## A82 Tarbet to Invernarnan upgrade project – alternative proposals

## **Helensburgh and District Access Trust's concerns about the proposals**

The upgraded section of the A82 by Pulpit Rock, projecting out over the loch

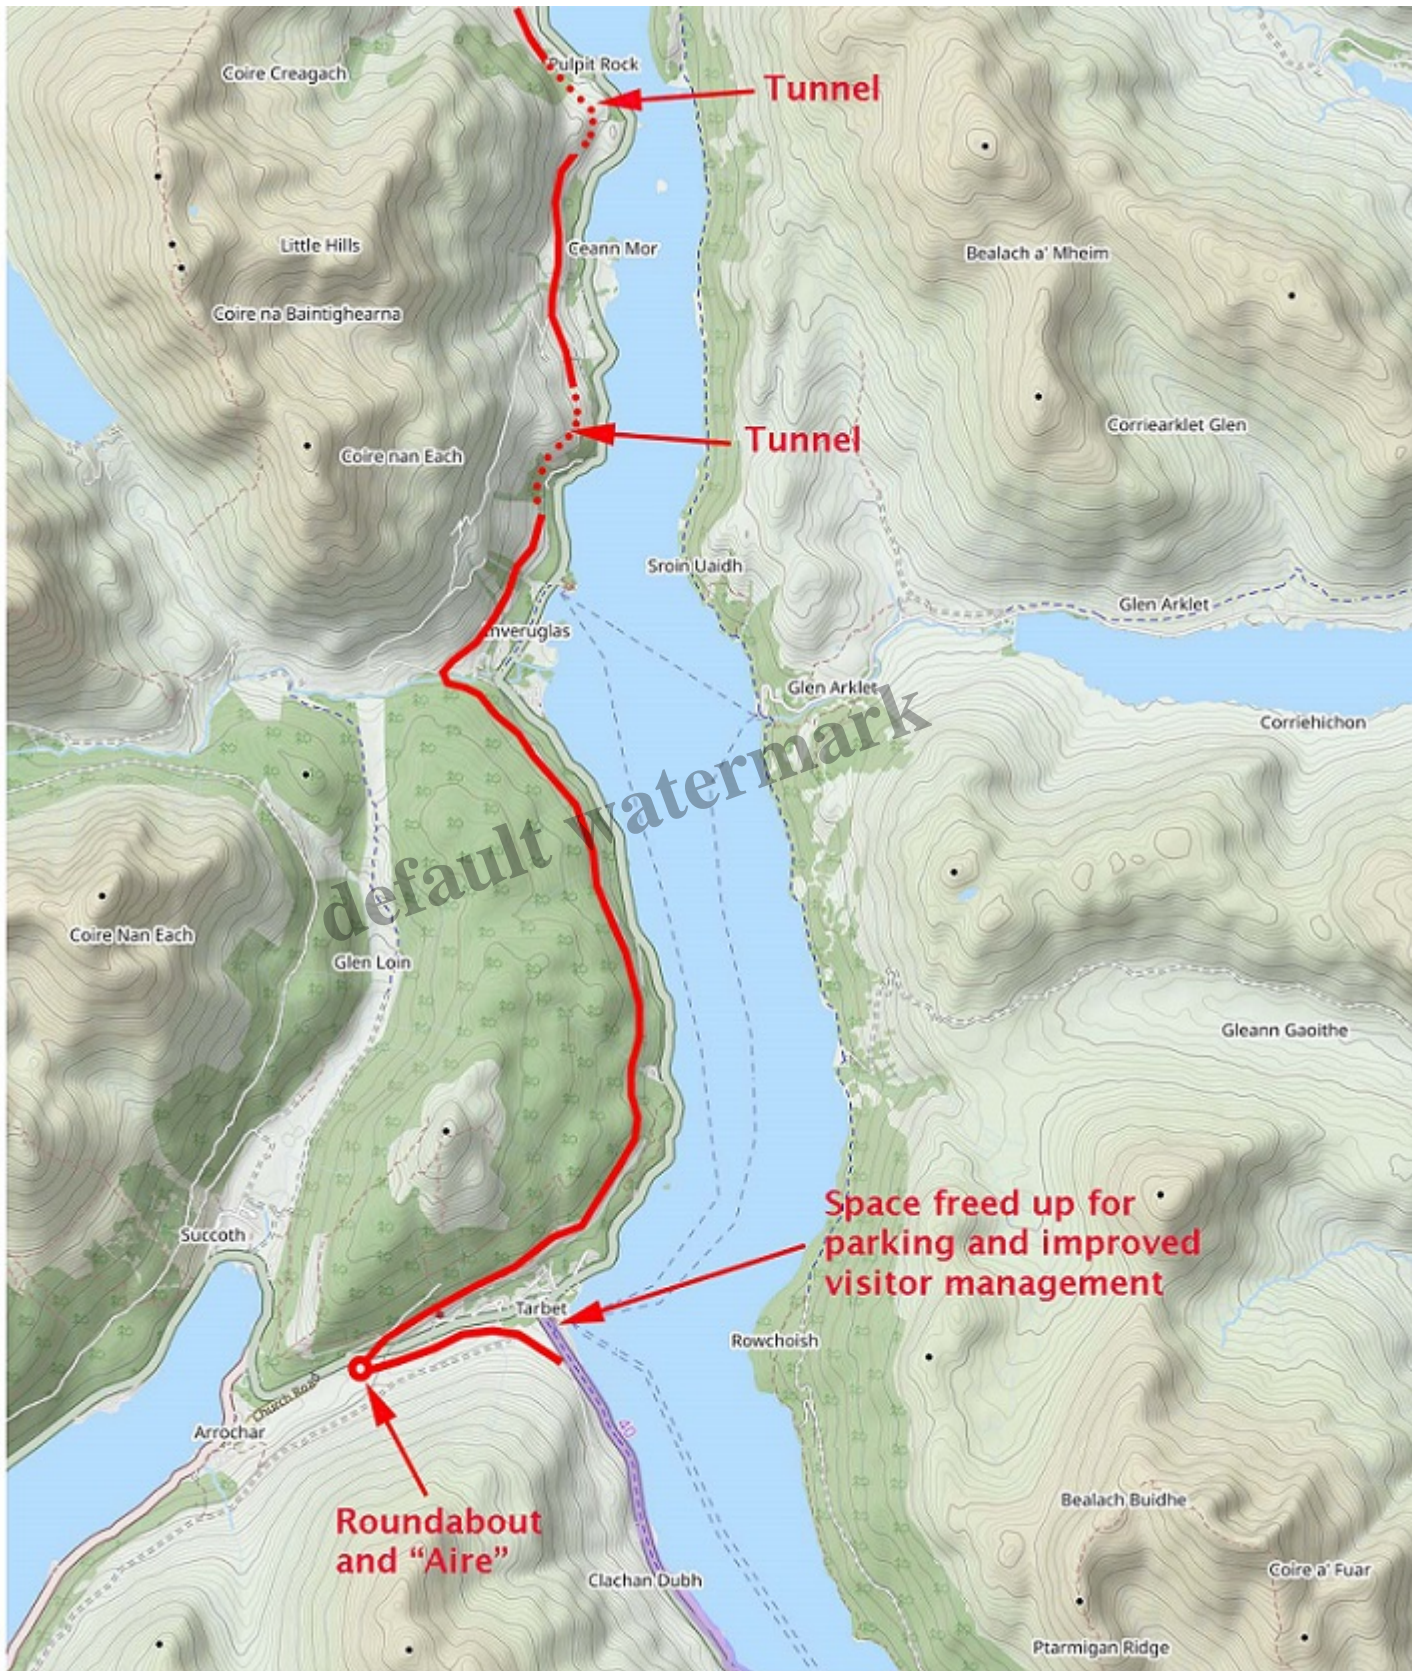
Viaducts across the bays bring the road into even closer proximity to the loch and will ruin the character of the shoreline in the bays that they cross. In the previous upgrade works south of Tarbet, which were completed some decades ago, there are several long sections where the new road was essentially built right on the shoreline, completely obliterating its character and destroying important freshwater littoral habitat. It seems that in a number of areas the current proposals for the area north of Tarbet involve a very similar approach which is both puzzling and regrettable, particularly given the National Park status enjoyed by the area now.

The new road will be much faster than before and being close to the shore, noise from the traffic will be even louder and will be a constant intrusion for surrounding wildlife as well as for people trying to enjoy Loch Lomond along the shore or out on the water. Sound travels very efficiently along the interface between water and the atmosphere, so West Highland Way walkers half a mile away on the opposite bank will also have their experience of the loch spoiled by the constant traffic racket.
